REDLINE REVISION NO. 5
MD 175 AT DISNEY ROAD; REVISED POLE LOCATIONS IN THE NW QUADRANT
[signature] TEDD TEAM LEADER APPROVAL — 1/24/2013 DATE

MD 175 (ANNAPOLIS ROAD) AT
26TH STREET / DISNEY ROAD
FORT MEADE, MD

MOT PHASE 1B - TRAFFIC SIGNAL PLAN

SCALE 1″ = 20′	ADVERTISED DATE 4/26/1984	CONTRACT NO. AA 797-501-585	
DESIGNED BY MICKEY CORNELIUS		COUNTY ANNE ARUNDEL	
DRAWN BY MICKEY CORNELIUS		LOGMILE 02017507.10	
CHECKED BY		TIMS NO.	
F.A.P. NO. SEE TITLE SHEET		TOD NO.	
TS NO. 1959D1	DRAWING SG-03.1 OF 26	SHEET NO. 123 OF 195

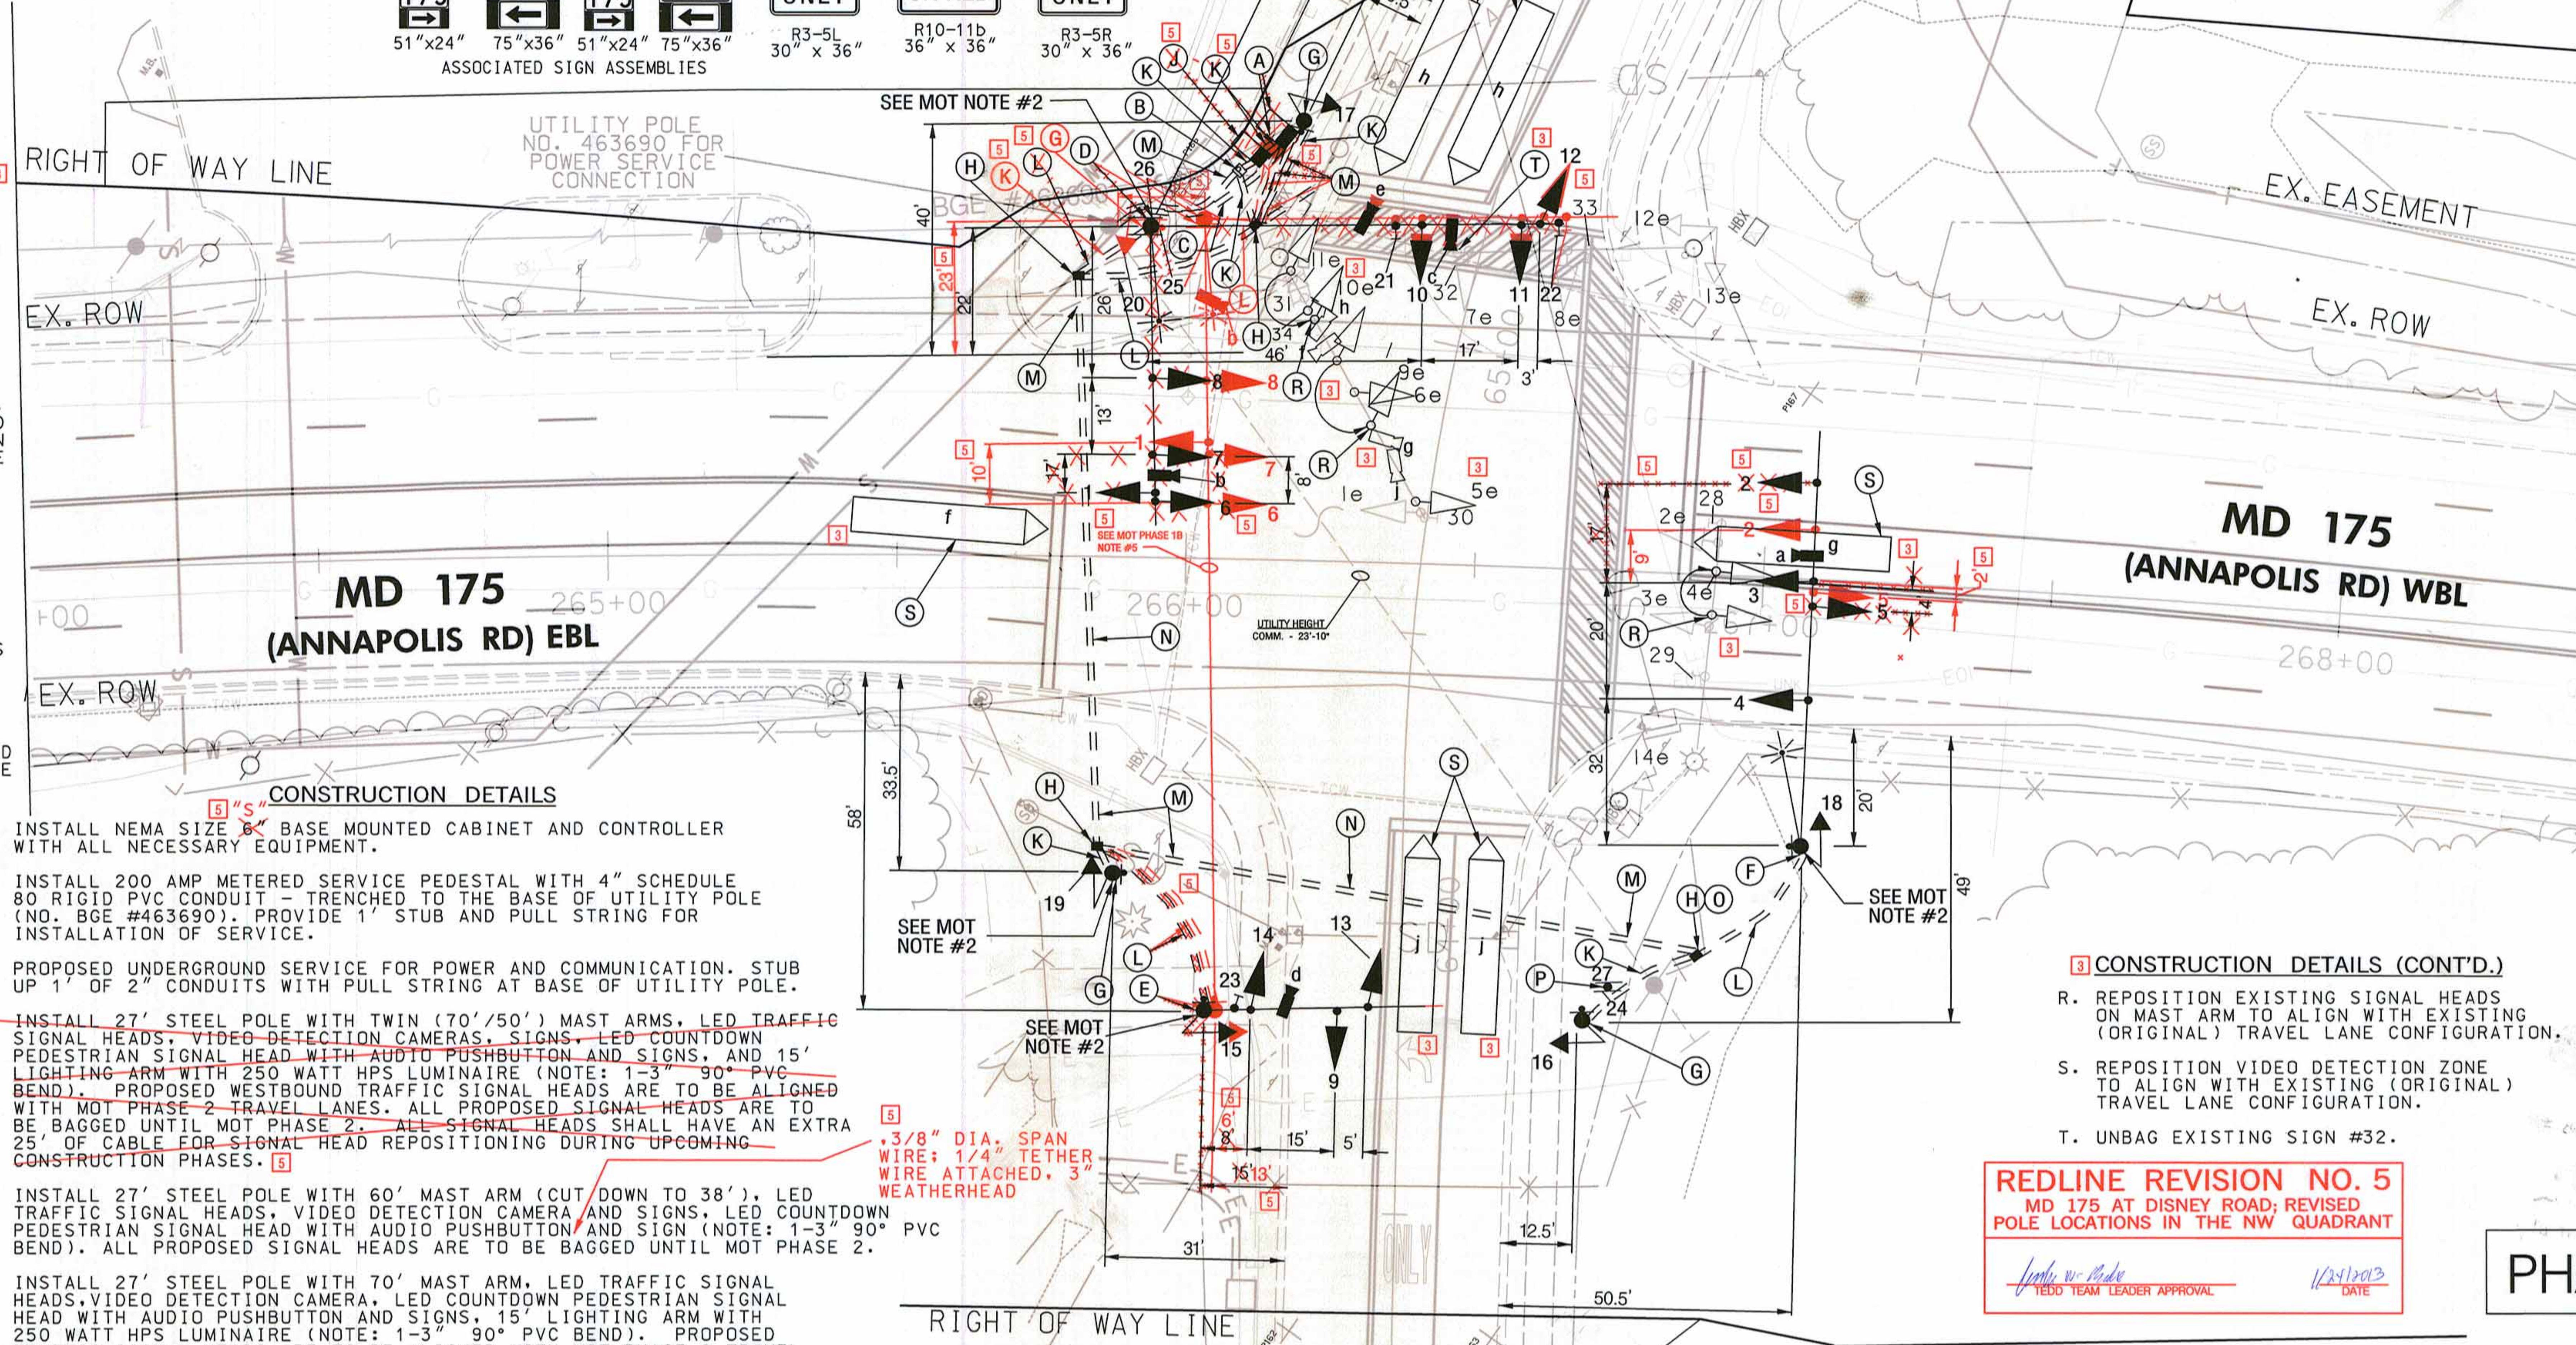
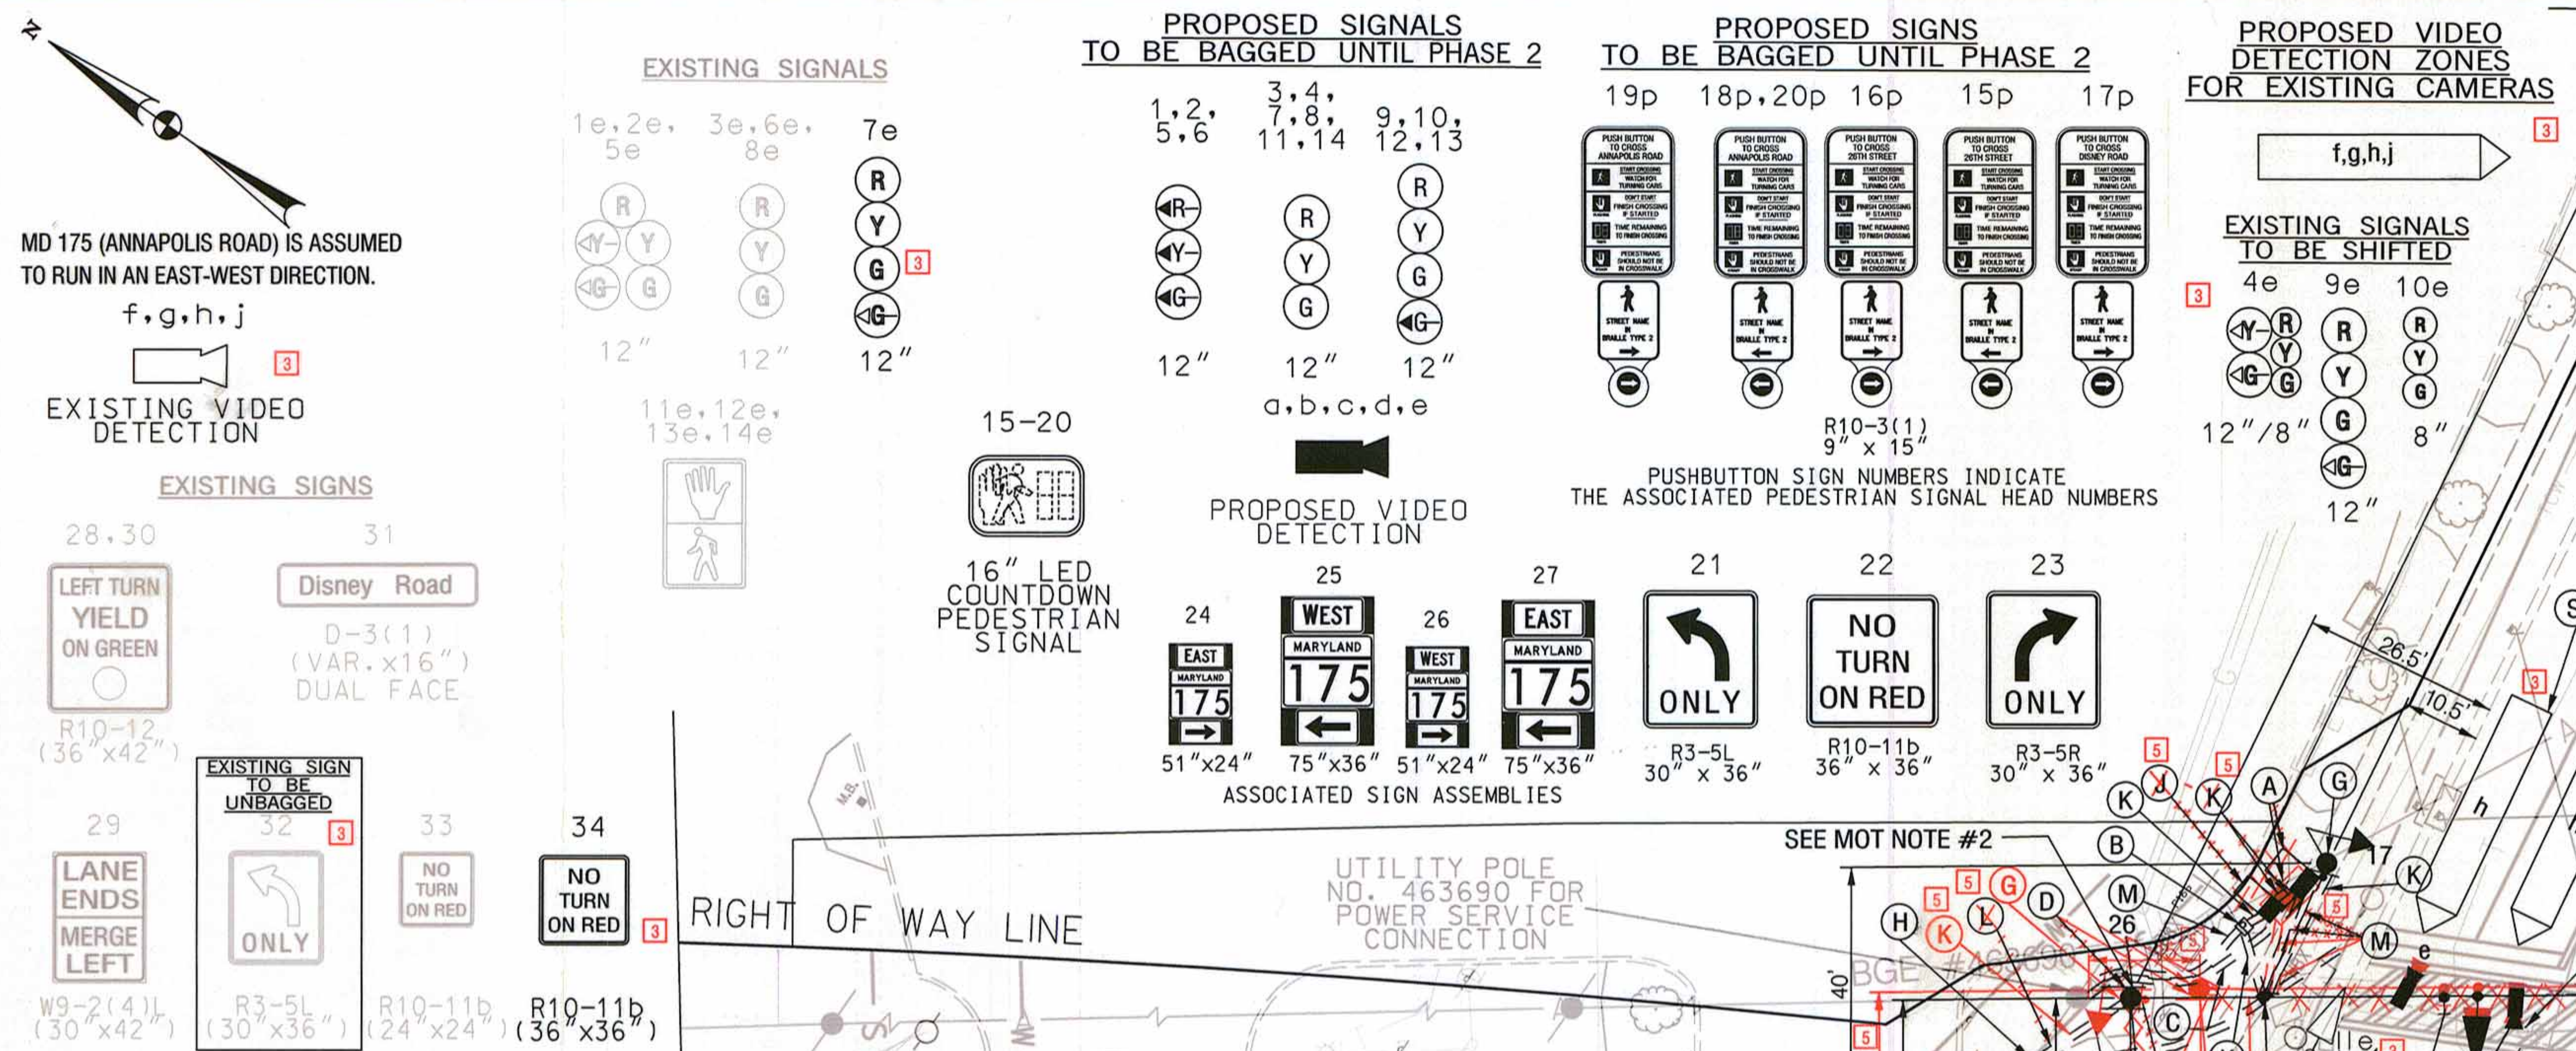
5. TEMPORARY SPAN WIRE SHALL BE MOUNTED AT 26′ ON THE MAST ARM UPRIGHT STRUCTURE AND HAVE A 5% SAG TO AVOID EXCESSIVE TENSIONING OF THE SPAN WIRE. MAINTAIN 17′ MINIMUM SIGNAL HEAD ROADWAY CLEARANCE. 5

D. INSTALL 27′ STEEL POLE WITH TWIN (70′/50′) MAST ARMS AT STA. 266+2.2, 58.3′ LT (50′ MAST ARM SHALL BE STORED FOR INSTALLATION DURING MOT PHASE 4); 3/8″ DIA. SPAN WIRE; 1/4″ TETHER WIRE ATTACHED; LED TRAFFIC SIGNAL HEADS; VIDEO DETECTION CAMERAS; SIGNS; 3″ WEATHERHEAD AND 15′ LIGHTING ARM WITH 250 WATT HPS LUMINAIRE (NOTE: 1-3″ 90° PVC BEND). PROPOSED WEST-BOUND TRAFFIC SIGNAL HEADS AND VIDEO DETECTION CAMERA SHALL BE ALIGNED WITH MOT PHASE 2 TRAVEL LANES. ALL PROPOSED SIGNAL HEADS SHALL BE BAGGED UNTIL MOT PHASE 2. ALL SIGNAL HEADS SHALL HAVE AN EXTRA 25′ OF CABLE FOR SIGNAL HEAD REPOSITIONING DURING UPCOMING CONSTRUCTION PHASES.

A. INSTALL NEMA SIZE ~~6″~~ 5 "S" BASE MOUNTED CABINET AND CONTROLLER WITH ALL NECESSARY EQUIPMENT.

~~D. INSTALL 27′ STEEL POLE WITH TWIN (70′/50′) MAST ARMS, LED TRAFFIC SIGNAL HEADS, VIDEO DETECTION CAMERAS, SIGNS, LED COUNTDOWN PEDESTRIAN SIGNAL HEAD WITH AUDIO PUSHBUTTON AND SIGNS, AND 15′ LIGHTING ARM WITH 250 WATT HPS LUMINAIRE (NOTE: 1-3″ 90° PVC BEND). PROPOSED WESTBOUND TRAFFIC SIGNAL HEADS ARE TO BE ALIGNED WITH MOT PHASE 2 TRAVEL LANES. ALL PROPOSED SIGNAL HEADS ARE TO BE BAGGED UNTIL MOT PHASE 2. ALL SIGNAL HEADS SHALL HAVE AN EXTRA 25′ OF CABLE FOR SIGNAL HEAD REPOSITIONING DURING UPCOMING CONSTRUCTION PHASES.~~ 5

~~J. INSTALL NEMA SIZE 5″ BASE MOUNTED CABINET FOR BATTERY BACKUP WITH ALL NECESSARY EQUIPMENT.~~ 5

APPROVALS	REVISIONS
TEAM LEADER	Ⓓ 5 REDLINE NO. 5 1/ /2013 INSTALL NEW PEDESTAL POLE IN THE NW QUADRANT, RELOCATE SIGNAL POLE — ENB
ASST. DIV. CHIEF	Ⓓ 3 REDLINE NO. 3 5/22/2012 SHOWING SIGNAL HEADS/PHASING FOR ORIGINAL LANE CONFIGURATION. — ENB
DIVISION CHIEF	Ⓓ BRAC RECONSTRUCT TRAFFIC SIGNAL SHA #. AA5805370 10/2010 TIMS NO. J-969 — ENB
OFFICE DIRECTOR (ORIGINAL ON FILE)
